PLANS AND DOCUMENTS referred to in the PDA DEVELOPMENT APPROVAL

Approval no: DEV2025/FLA/4175
Date: 06 February 2026

PROJECT
HERCULES STREET

SITE ADDRESS
19 HERCULES ST HAMILTON, BRISBANE QLD 4000

DRAWING TITLE
SITE ANALYSIS

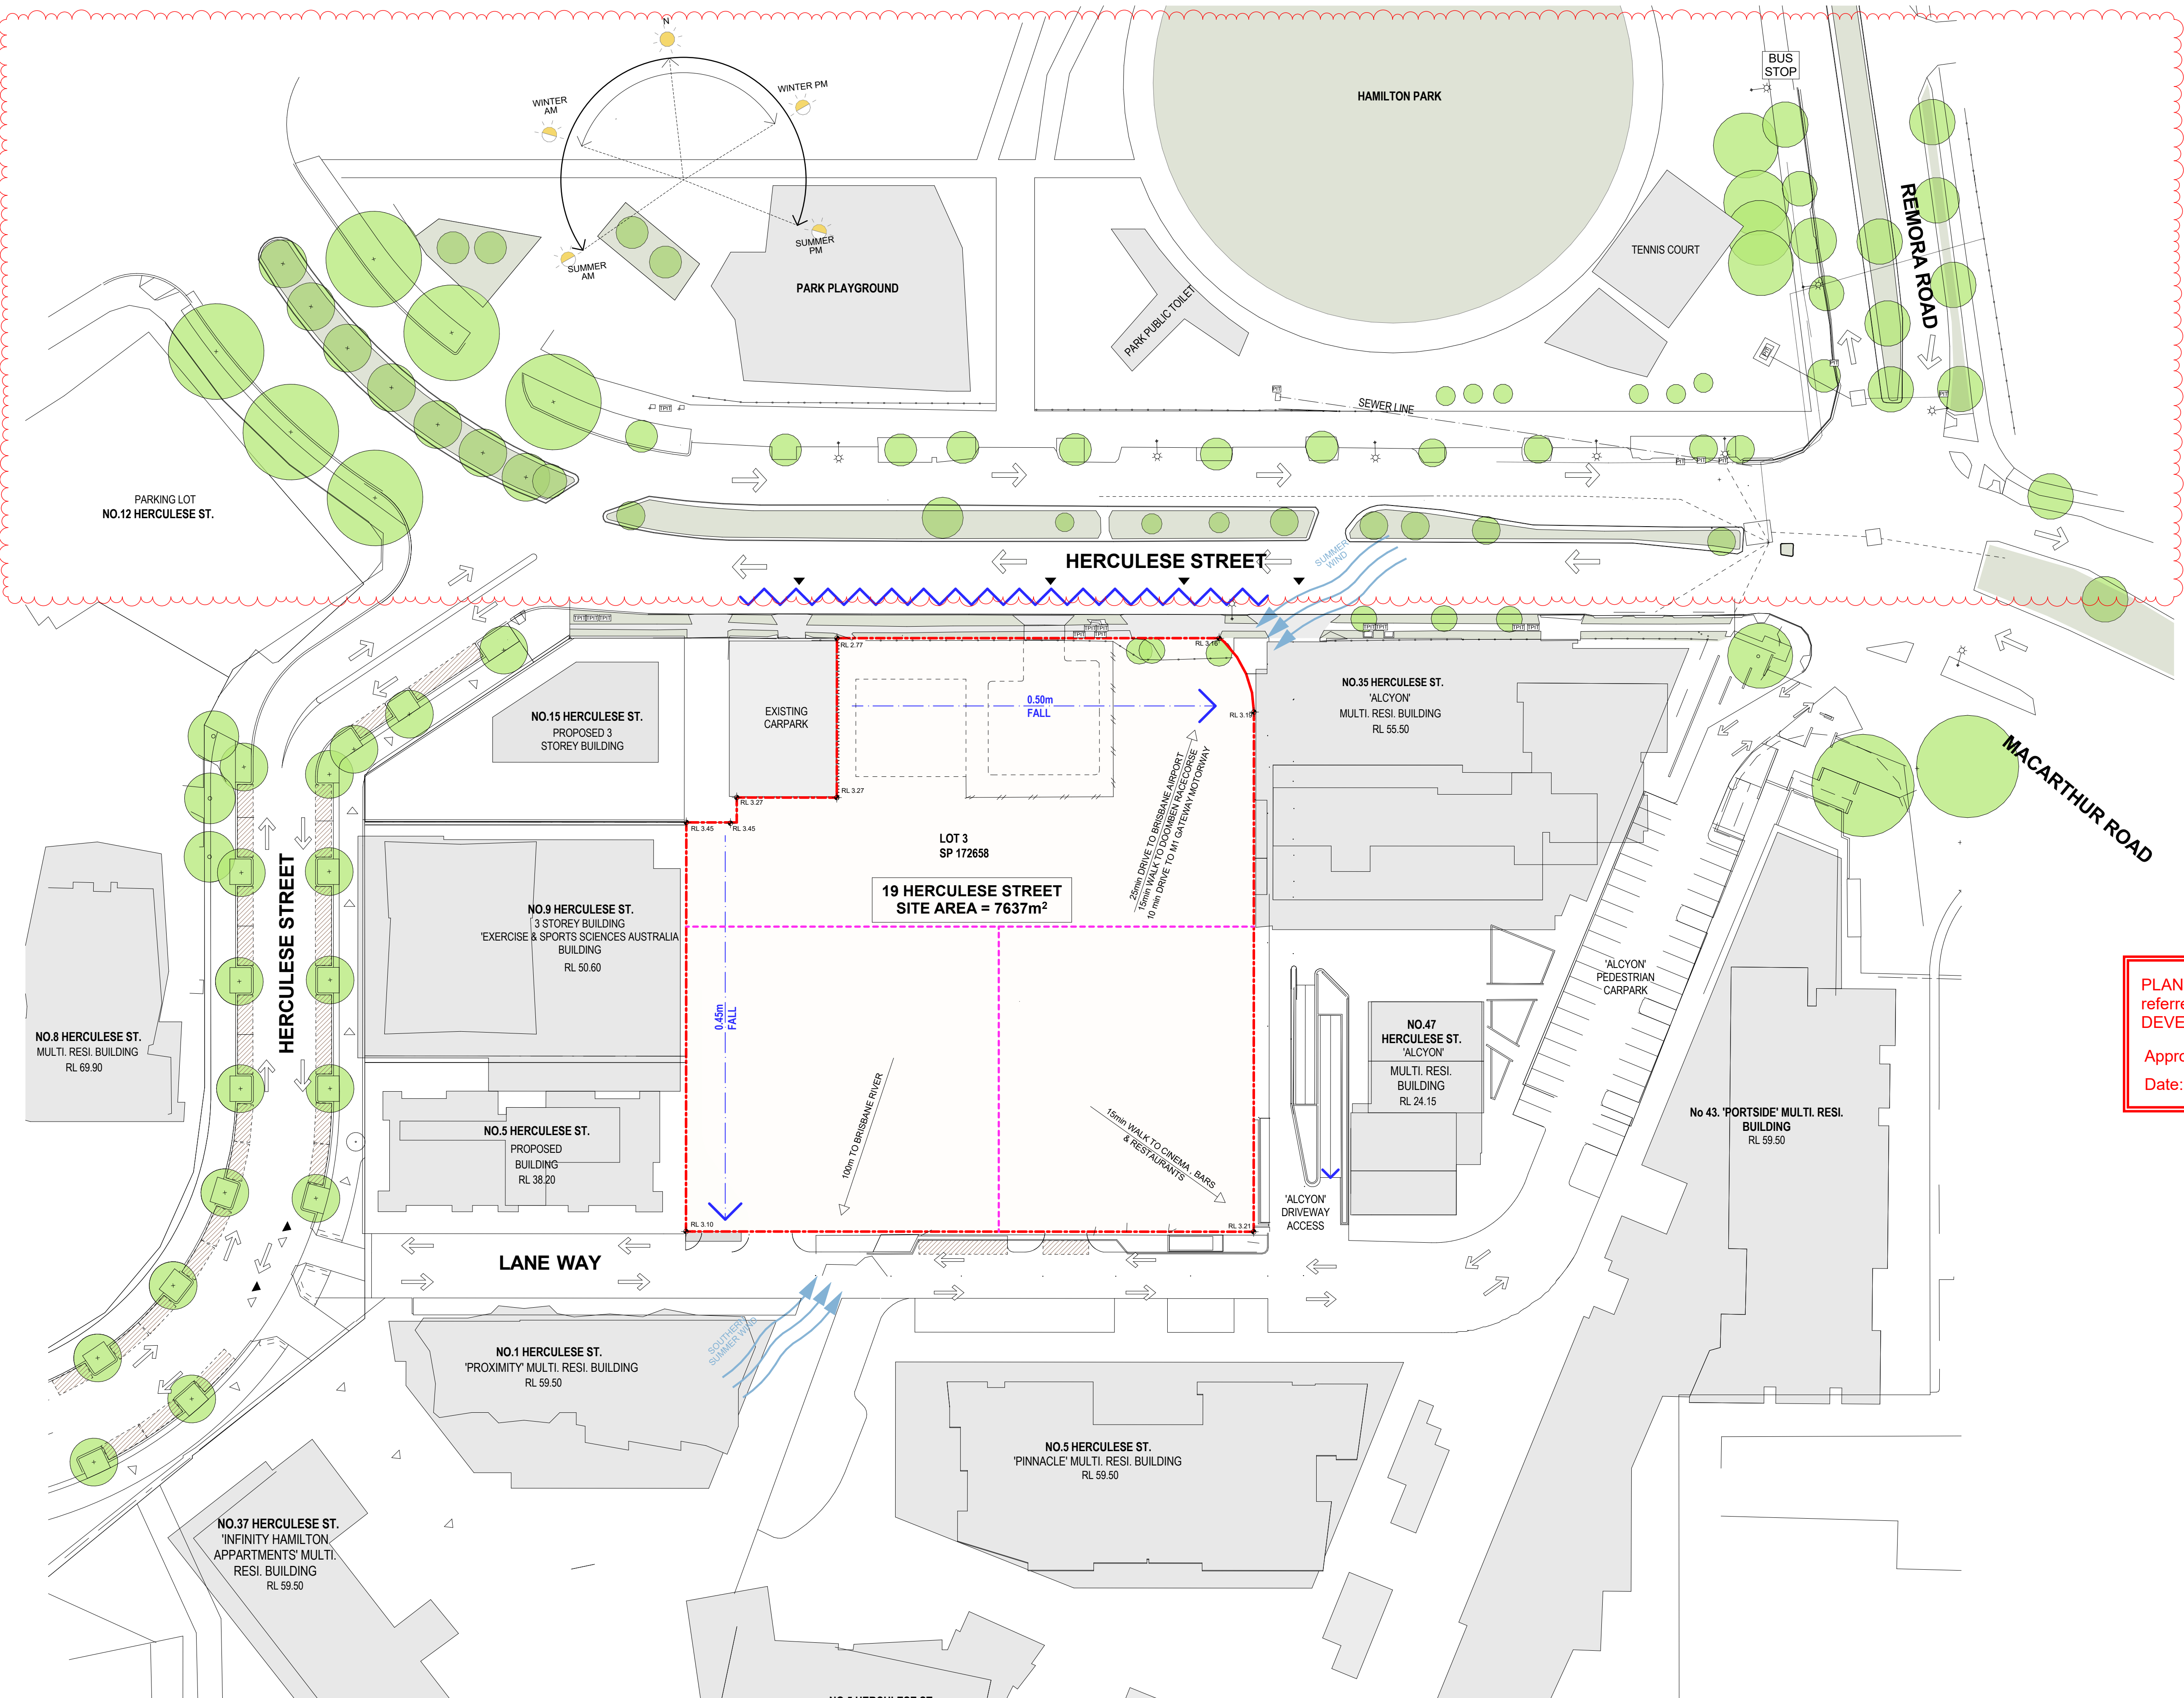
B-01	SITE CONTEXT BACKGROUND AMENDED
------	---------------------------------

PROJECT STATUS
DEVELOPMENT APPLICATION
DRAWING TITLE
BASEMENT 3 PLAN

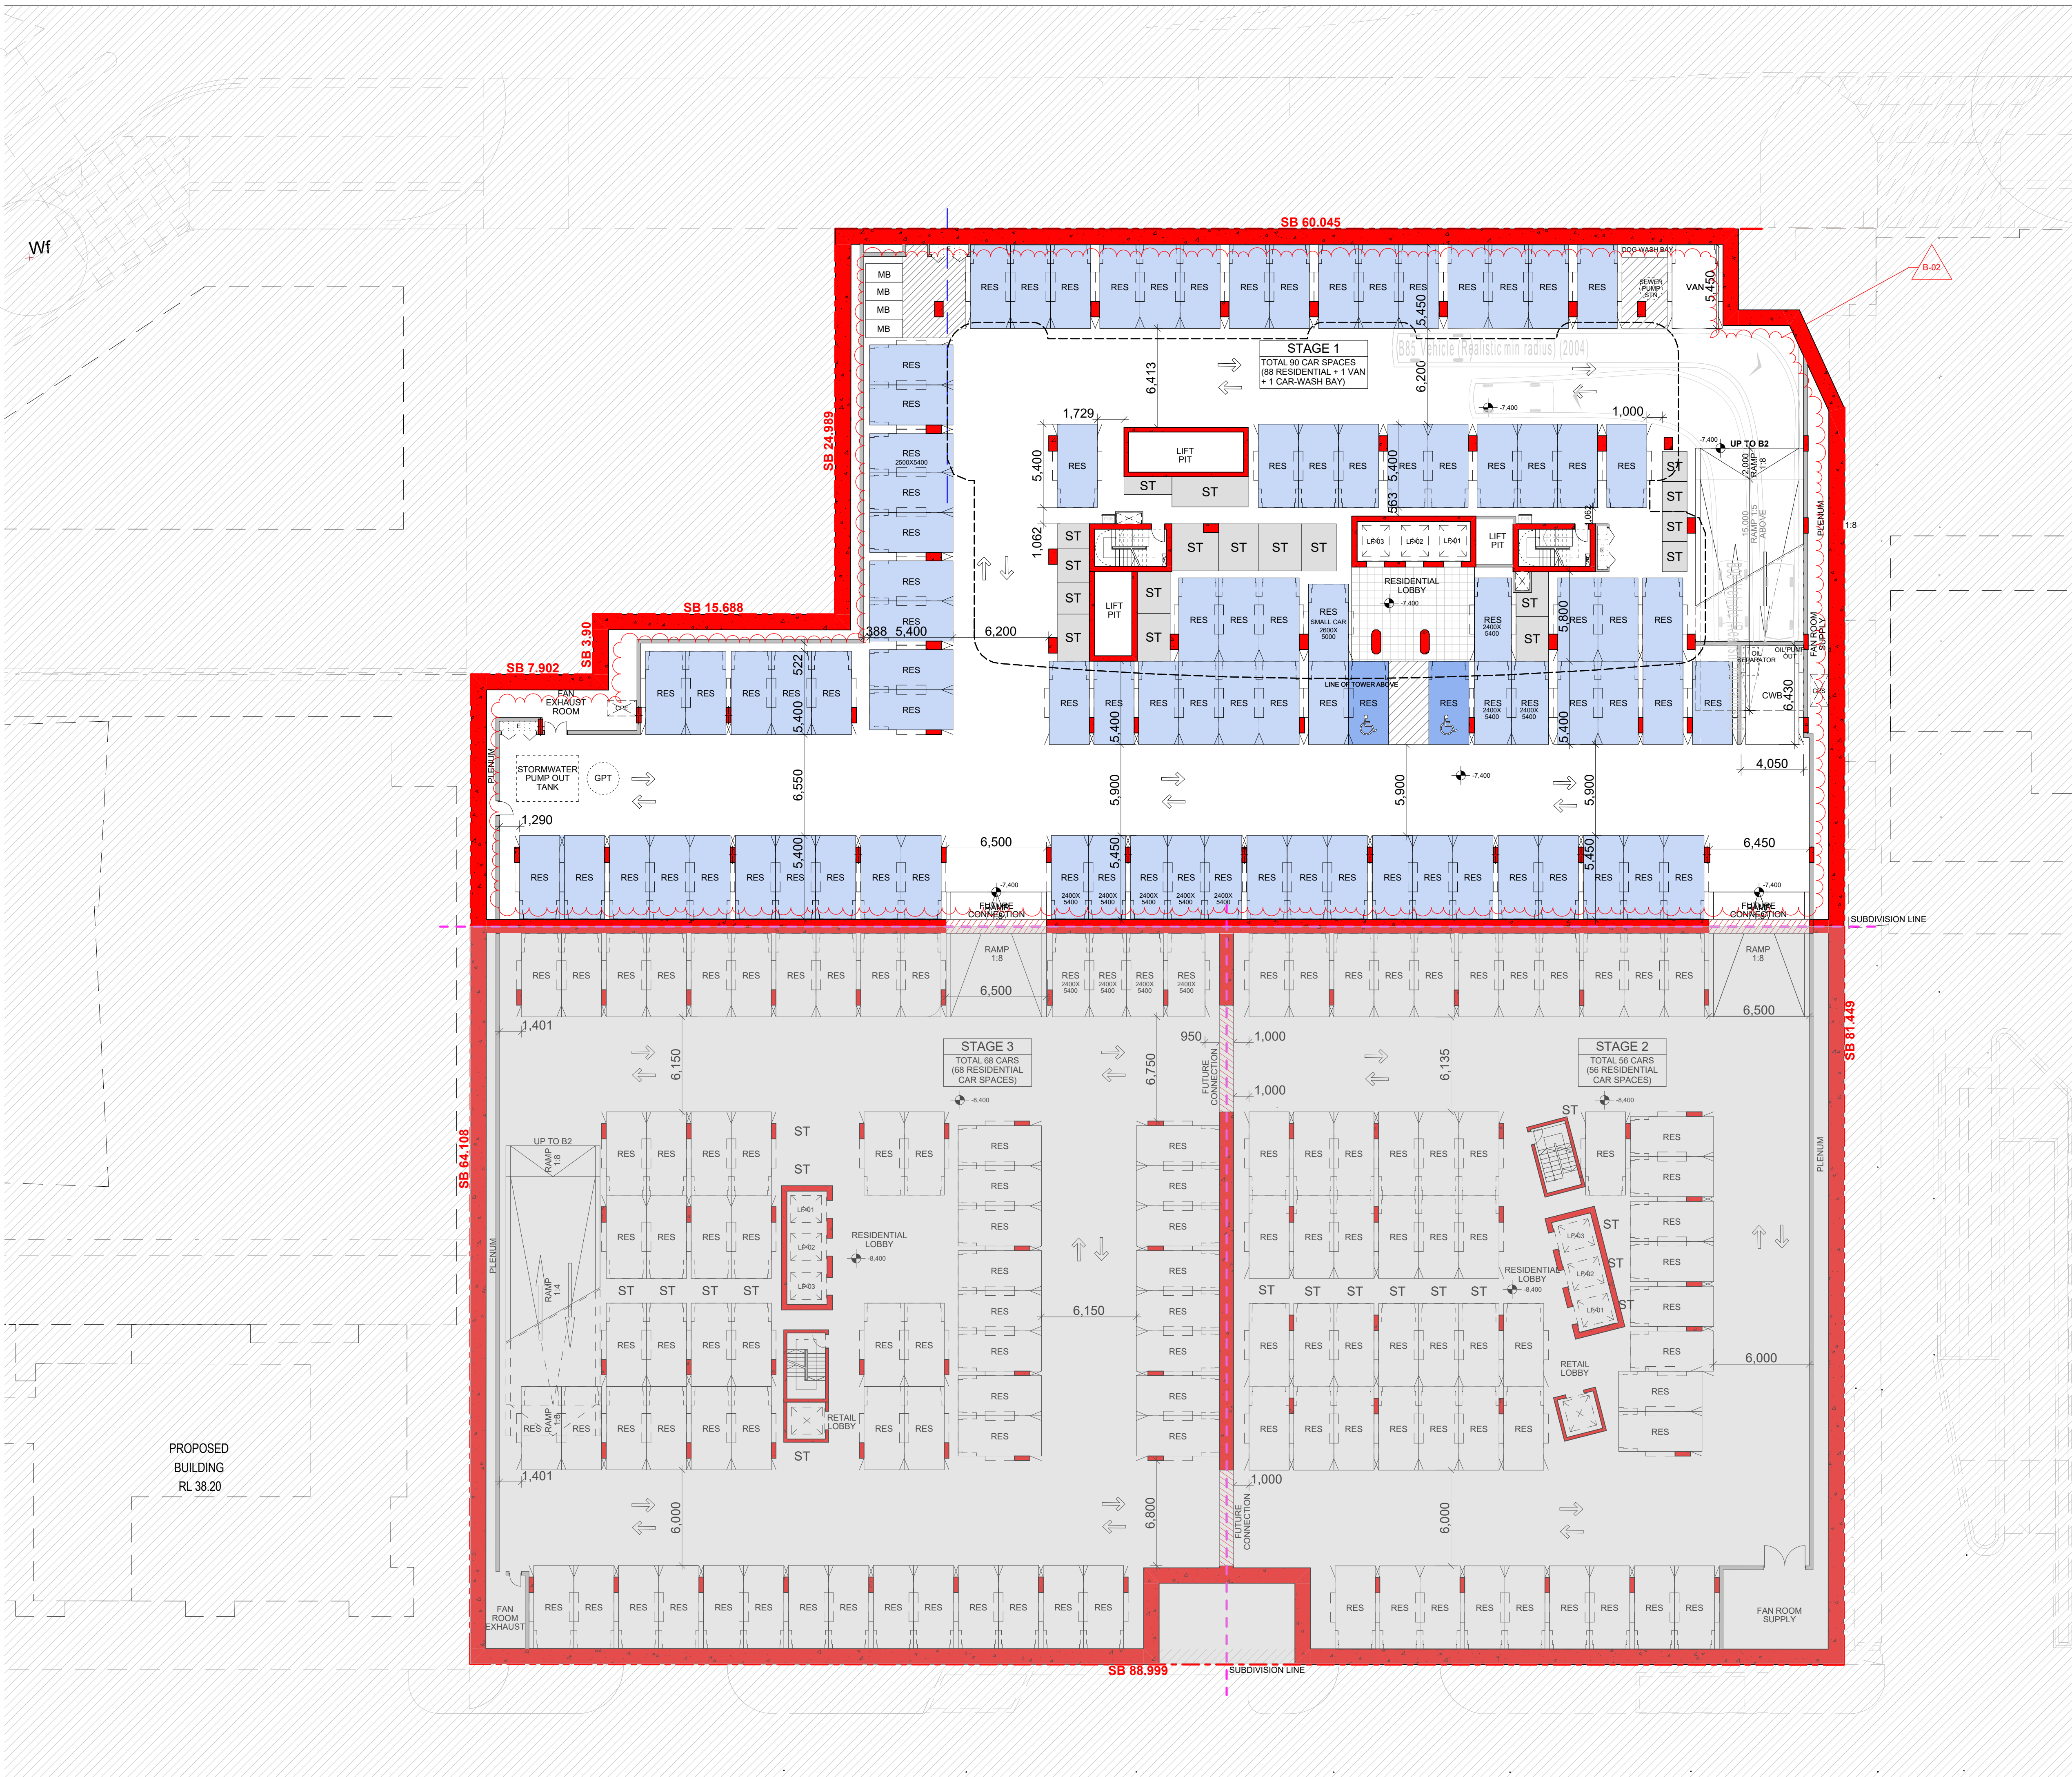
CHANGE	DESCRIPTION
B-02	BASEMENT LAYOUT OPTIMIZED AND LOWER BASEMENT LEVELS (BASEMENT 4 AND 5) REMOVED

DRAWING TITLE
GROUND FLOOR

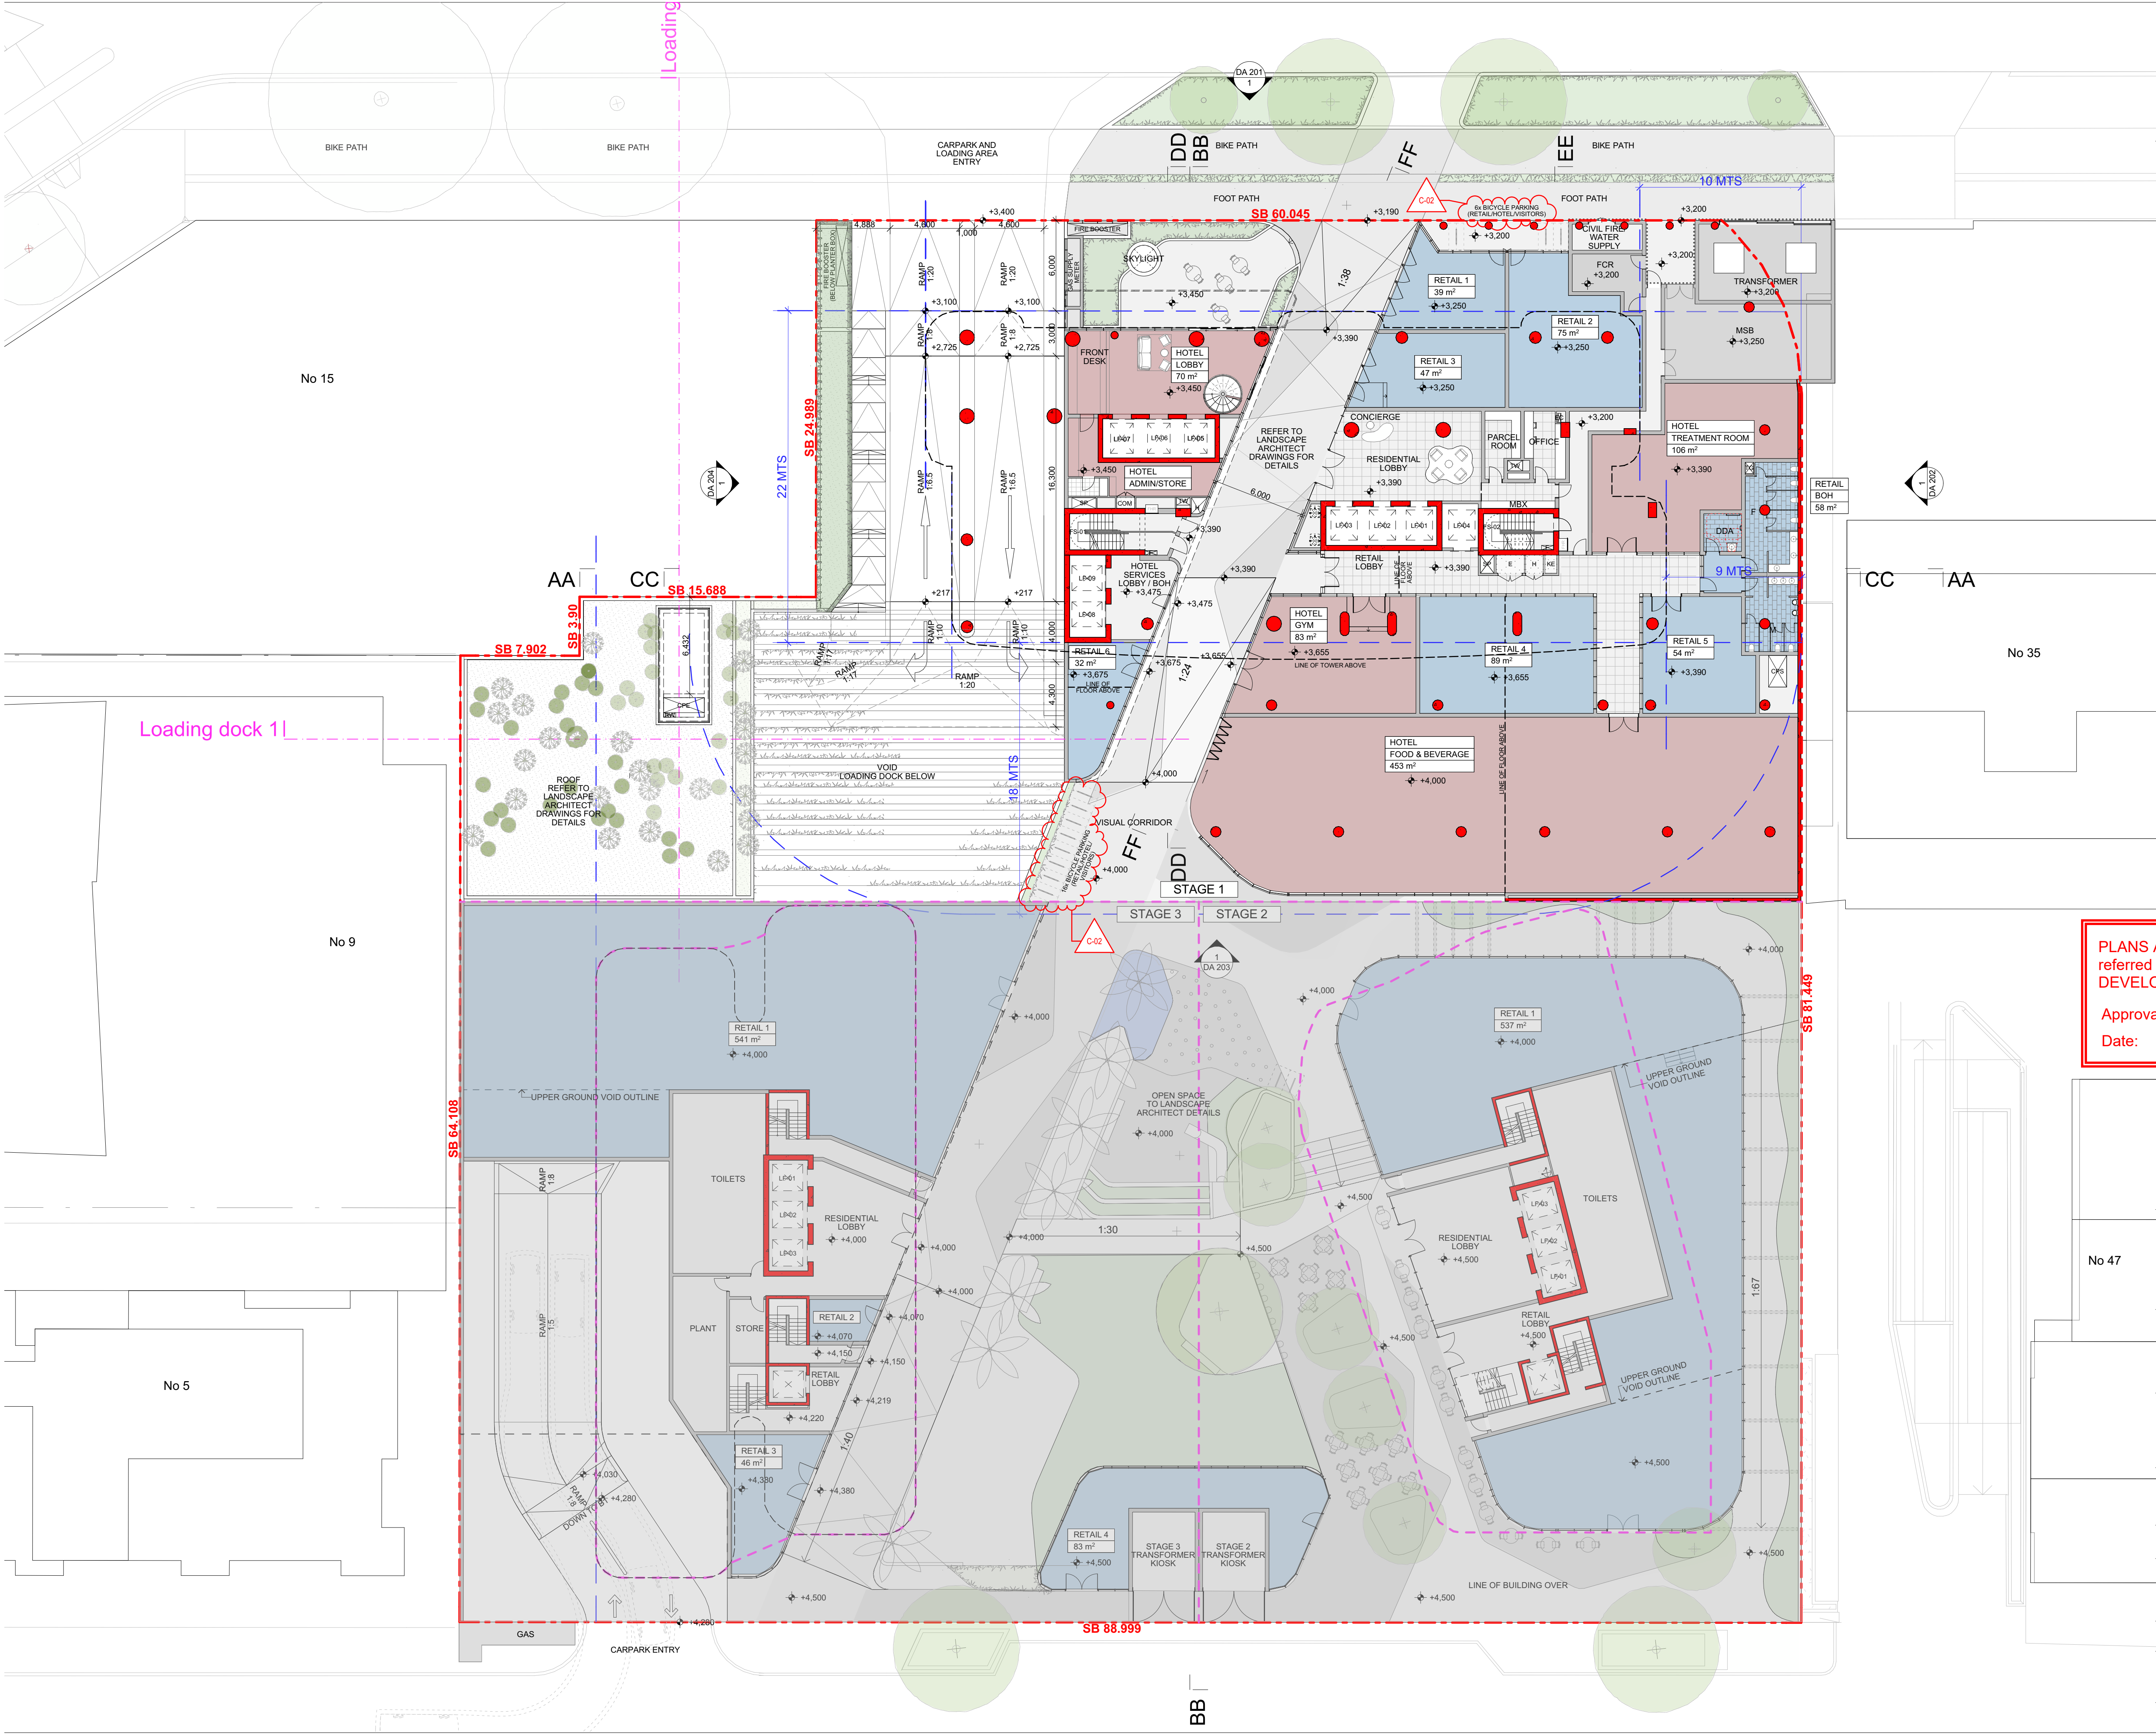
CHANGE	DESCRIPTION
C-02	BICYCLE SPACES UPDATED
